CMA Reference No: CCMA-F-2023-00699
Document No: 1
Date: 03 August 2023

CMA Reference Number: CCMA-F-2023-00699
Re: FIR - Flood Information Request
Location **Street** 60-62 Morgan Street Norlane VIC 3214
Cadastral Lot 1 TP2679, Parish of Moorpanyal

Proposed Development Description: Guidance sought for proposed development particularly regarding a bridge proposed over Cowies Creek
on the abovementioned proposed development location.

Figure 1: Flood hazard from Water Technology

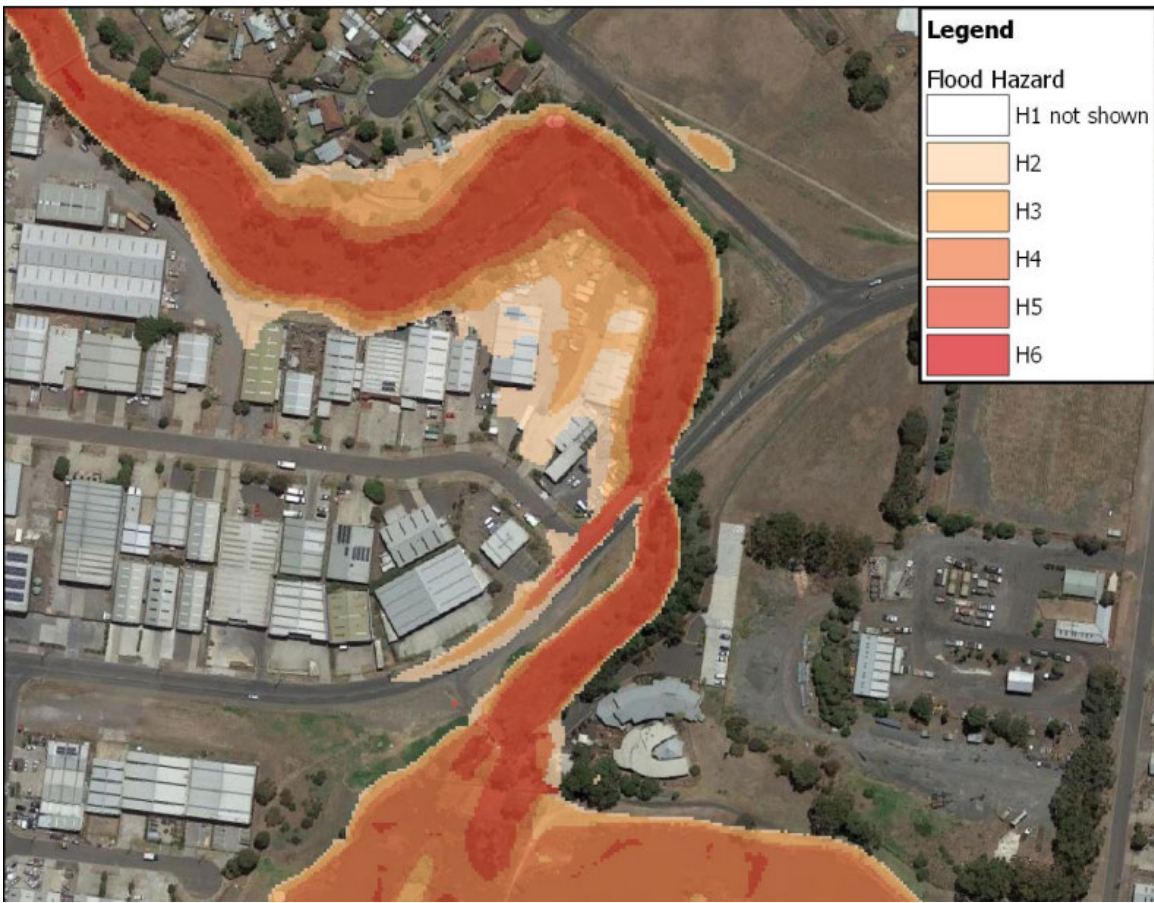
The proposed development of the Wathaurong Aboriginal Cooperative facility has come into some difficulty on access, an issue identified by the Authority early in the project. At present there is no safe access/egress as the existing bridge is impacted during floods smaller than the 10% AEP flood event. Numerous scenarios were tested and posed by the applicant during a meeting (dated 17 July 2023) followed by an email dated 20 July 2023. There is scope to increase the capacity of the bridge, however, Morgan Street experiences significant flooding rendering the proposed option untenable.

The applicant proposes to retain the use of the existing bridge as the primary access, using a Flood Emergency Response Plan (FERP) to mitigate the risk, by stipulating emergency access via Council owned land to the North. Once ownership is transferred to the Wathaurong (2-3 years' time), this access would become permanent, and the access to the existing bridge would be blocked by metal posts, to prevent access during flood events, this would be a requirement of the updated FERP.

The detailed flood study which exists, the non-habitable nature of the facility, the safe emergency access/egress and the temporary (<12 hours) inundation duration, result in the proposed option seeming suitable for the development to proceed.

In light of the above information the Authority **would not object** in principle to the use of the existing bridge as part of a Flood Emergency Response Plan subject to the following minimum condition(s):

1. A Flood Emergency Response Plan (FERP) to the satisfaction of Authority must be submitted and approved. When approved, the FERP will be endorsed and will form part of the planning permit. The FERP must be prepared by a suitably qualified person and must be in accordance with industry best practise. The FERP must include:
 - a. Consideration of the appropriateness of a flood monitoring system (i.e. upstream gauging and warning dissemination) and make recommendations if appropriate.
 - b. Create both warning and evacuation measures for occupants and staff on-site including 'defined triggers' and the most appropriate 'safe areas' and 'safe evacuation routes'.

- f. The proposed route for the emergency access must be an all-weather access road so that emergency vehicles can access the site during a flood event.

2. The finished floor level of the proposed development must be a minimum of 300 millimetres above the applicable 1% AEP flood level.
 3. The emergency access road to the north must be constructed to a suitable standard to allow all-weather access and be suitable for emergency vehicles access.
